Access Compliance Report Public Rights-of-Way (Curb Ramps)

Main Street: OLIVE_ST Cross Street: CELESTINE_CIR Location: NW

ADA ID: RPAT211029123528 Ramp Type: Type 4 - Parallel Initial Pass/Fail: Pass Overall Compliance: No Severity Score: 16

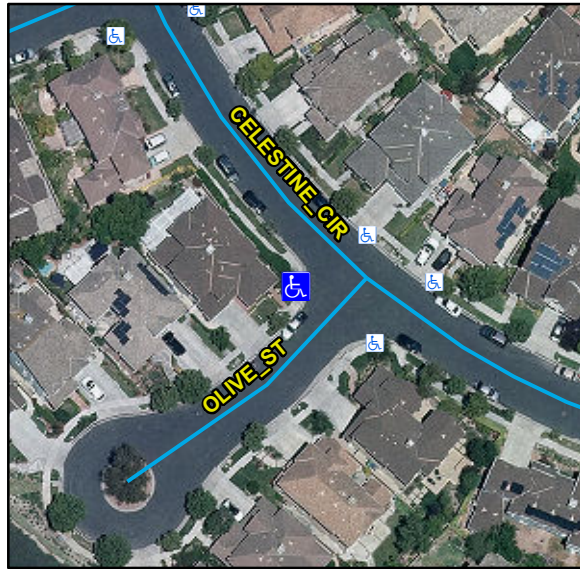
Compliance	Description	Data	Compliance	Description	Data
N/A	Ramp Length LT (in)	109	N/A	Ramp Length RT (in)	102
Yes	Ramp Width LT (in)	54	Yes	Ramp Width RT (in)	54
Yes	Ramp Run Slope LT (%)	7	Yes	Ramp Run Slope RT (%)	6
Yes	Ramp Cross Slope LT (%)	1	No	Ramp Cross Slope RT (%)	2.1
N/A	Landing Present	Yes	No	DWS Provided	No
N/A	Landing Length (in)	54	N/A	DWS Contrast	N/A
Yes	Landing Width (in)	70	N/A	DWS Length (in)	N/A
Yes	Landing Run Slope (%)	1.3	N/A	DWS Full Width	N/A
Yes	Landing Cross Slope (%)	1.8		DWS Offset Type	N/A
N/A	Landing Movement Obstructed?	No	N/A	DWS Offset Left (in)	N/A
	Landing Movement Type	Curb	N/A	DWS Offset Right (in)	N/A
N/A	Landing Shared	No			
N/A	Clear Space	Yes			
N/A	Clear Space To Crosswalk (in)	48			
N/A	Marked Crosswalk 1	No	N/A	Marked Crosswalk 2	No
	Crossing 1 Direction	S		Crossing 2 Direction	E
N/A	Marked Crosswalk 1 Width (in)	N/A		Marked Crosswalk 2 Width (in)	N/A
N/A	Ramp Inside Crosswalk 1	N/A	N/A	Ramp Inside Crosswalk 2	N/A

Crossing 1 Slope (%)	2.4		Crossing 2 Slope (%)	2.8
	Crossing 1 Cross Slope (%)	2.3		Crossing 2 Cross Slope (%)	1.2
No	Gutter Ponding	Yes	N/A	Curb Slope	7.2
Yes	Gutter Lip Height (in)	0		Road Run Slope (%)	0.5
No	Gutter Run Slope (%)	7.3		Road Cross Slope (%)	0.8
Yes	Gutter Cross Slope (%)	0.6	No	Perpendicular Joint Present	No
Yes	Overall Surface Condition	Acceptable			
	Cross Gutter Present?	No		Spandrel Present?	No
	Replace Cross Gutter?	N/A		Replace Spandrel?	N/A

Remove & Replace Curb Ramp With Two New Directional Ramps or Equivalent. Remove & Replace Gutter.
